Commission of Architectural Review

4. COA-172312-2025	Final Review Meeting Date: 9/23/2025
Applicant/Petitioner	Jennifer Lauer
Project Description	Undertake site improvements, including parking reconfiguration, new pathways, plantings, lighting, and signage.
Project Location	
Address: 12 E Franklin Street	
Historic District: Zero Blocks East and West Franklin Street	
<p>High-Level Details:</p> <p>The applicant proposes landscape and site improvements at the subject property, including the reconfiguration of circulation paths, new native plantings, expanded tree canopy, subtle site lighting, and the installation of a freestanding sign. The scope also includes selective demolition of brick paving at the rear, while retaining the historic front brick walkway and mature magnolia trees. Additional elements include granite curbing, new connected garden areas, utility screening and limited site furnishings. No exterior alterations to the primary historic building are included in this application.</p>

Figure 7: Proposed Plan

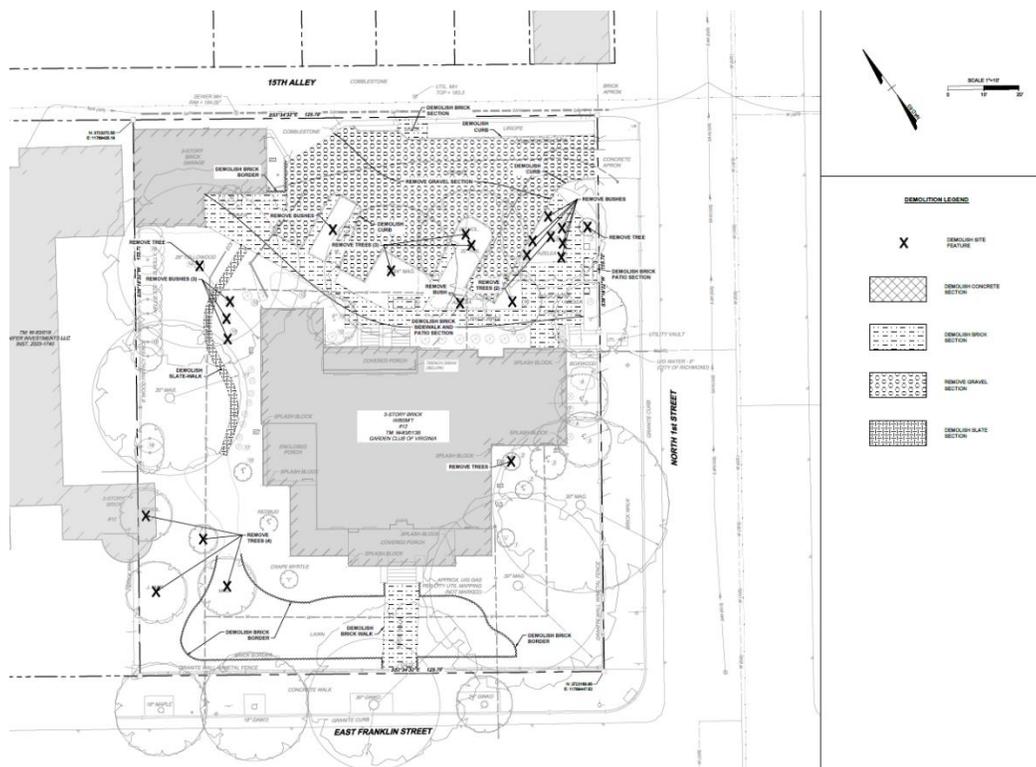
Guideline Reference	Reference Text	Analysis
Standards for Site Improvements, p.76	<i>Commercial parking should be confined to the sides and rears of buildings.</i>	The project reorganizes the rear parking with 90-degree spaces, including one ADA space and aisle, and improves circulation with stabilized decomposed granite pathways edged in steel. <u>Staff recommends approving the reconfigured parking and circulation.</u>
Standards for Site Improvements, p.76	<i>8. Landscape design should enhance the streetscape and contribute a strong aesthetic along street frontages. Appropriate landscaping should buffer the visual severity of surface parking lots from view. Vacant lots, large expanses of blank wall and other unattractive streetscape features (i.e. utilities, rear yard trash depots, etc.) can also be screened effectively with appropriate landscaping.</i>	The “river path” reconfiguration introduces a longer winding pedestrian route that connects the formal lawn with seating areas and smaller thematic garden spaces, which activate the the garden while maintaining the property’s main elevation layout. This new pathway enhances the pedestrian experience of the gardens and adds functionality without diminishing historic character. <u>Staff recommends approving the design of the “river path” as compatible with the site’s character.</u>

Figure 8: Demolition Plan

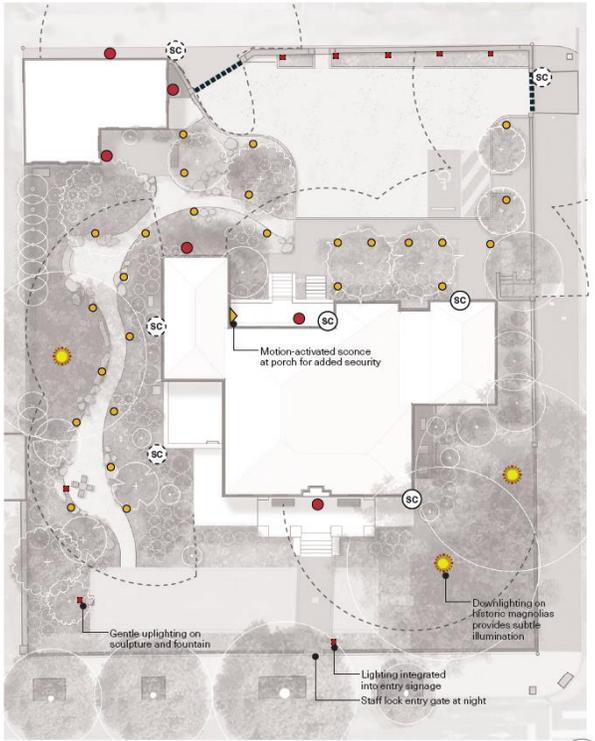
Mechanical Equipment, p.68	<p>3. <i>HVAC equipment on the ground should be appropriately screened with fencing or vegetation.</i></p>	<p>The proposed plan includes a timber enclosure fence to screen utility equipment on the east side of the property. This is consistent with guideline recommendations, minimizing visual impact of mechanical equipment from the public right-of-way.</p> <p><u>Staff recommends approval of the proposed utility screening.</u></p>
Standards for Site Improvements, p.76	<p>5. <i>Mature trees contribute to the character of Old and Historic Districts, provide visual interest, reduce the negative impacts or parking areas and ease the effects of temperature and wind conditions. Every effort</i></p>	<p>The application maintains the historic magnolia trees on East Franklin Street and existing brick entry walkway (as confirmed by applicant, stating that the demolition plan incorrectly designates the entry walkway bricks as an area to remove), and demolition will be limited only the paving in the rear patio, in the context of improving the parking footprint</p>

<p><i>should be made to preserve and maintain them.</i></p>	<p>and “river” pathway. This approach preserves key site features visible from the public right-of-way, consistent with best preservation practices. There are no planned alterations to the building on site.</p> <p><u>Staff recommends that any exterior alterations to the primary historic building must be submitted under a separate application for review and approval.</u></p>
--	---	--
